LAKE COUNTY
Investing in People
and Our Communities

Enclaves of Woodbine
Subdivision
Vernon Township

Final Plat & Final Engineering

October 31, 2018

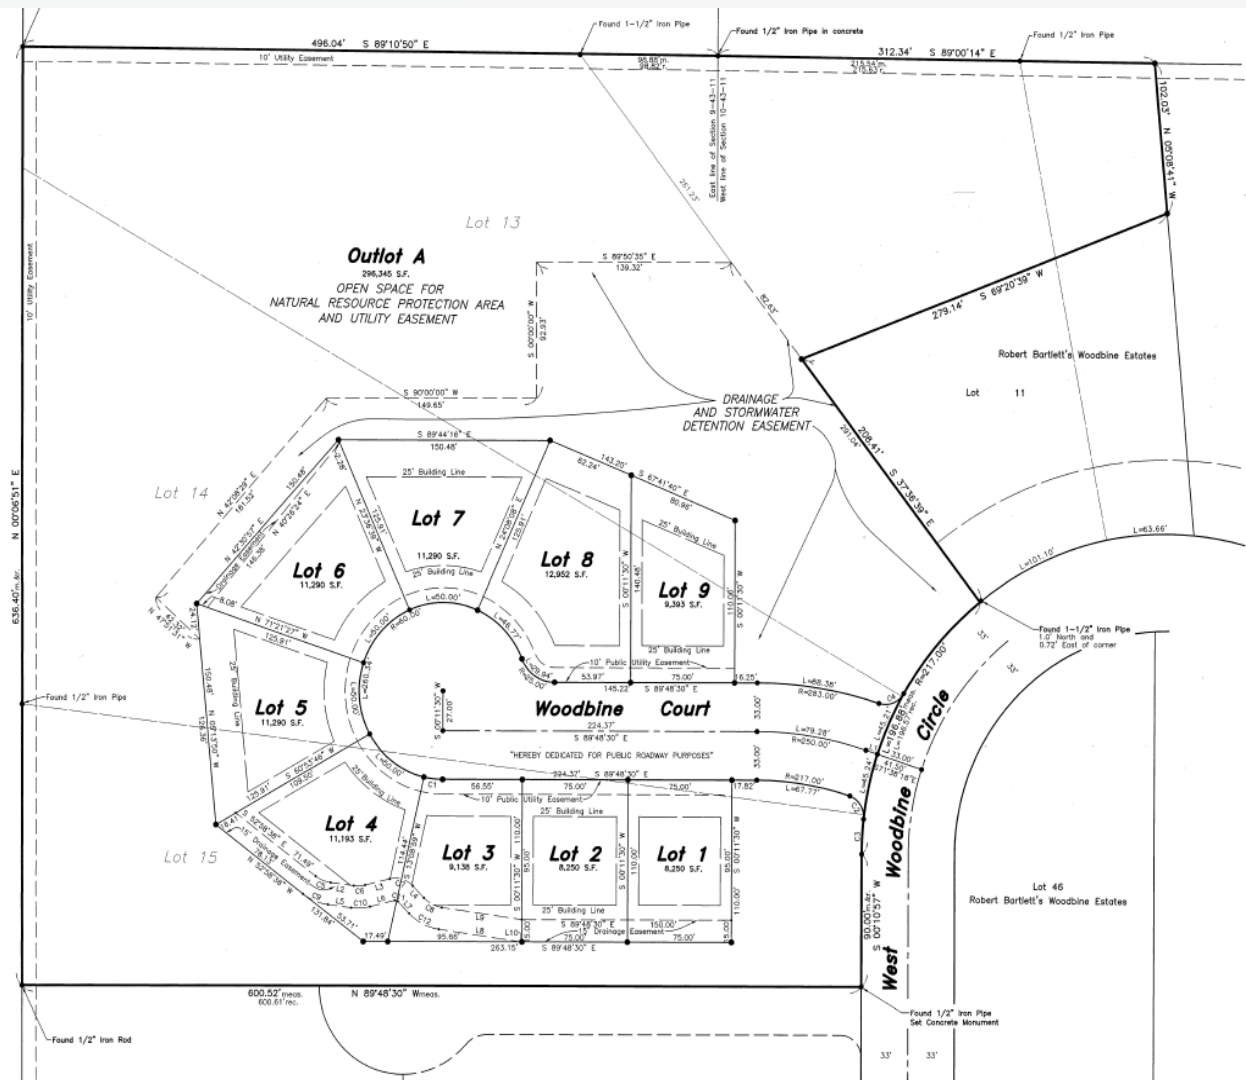
Q4. The houses will require excessive elevation due to on-site fill.

A4. There is 2-3 feet of fill proposed on portions of the site to place the road and utilities. Any foundations requiring additional elevation will be constructed with additional cladding (standard industry practice).
